Integrated Device Technology, Inc.
6024 Silver Creek Valley Road, San Jose, CA - 95138

PRODUCT/PROCESS CHANGE NOTICE (PCN)

ATTACHMENT 1 - PCN # : A1303-05

PCN Type: Assembly Process and Material Change

Figure 1: Illustration of Interposer Inserted between top die and bottom die (Top View)

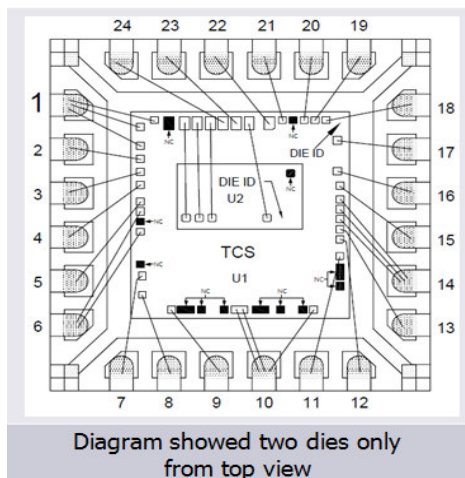
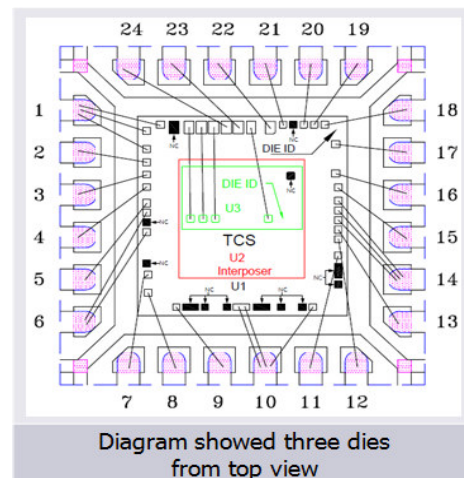
This notification is to advise our customers that IDT has successfully completed the qualification of stack die assembly with interposer. An interposer will be added in between the top die and the bottom die to improve assembly yield.

The die attach material for the top die will change to NEX-130SB-25 and for the bottom die to 8200T.

Old: Without Interposer

New: With Interposer

Figure 2: Illustration of Interposer Inserted between top die and bottom die (Side View)

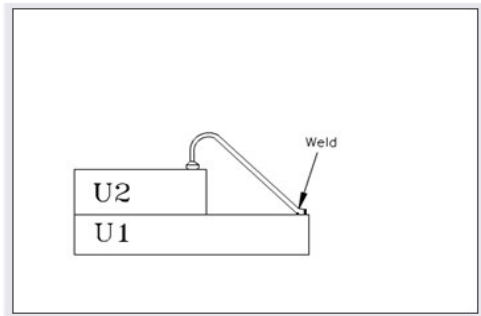
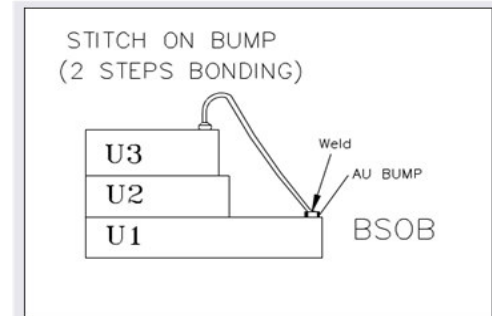
Old: Without Interposer

New: With Interposer
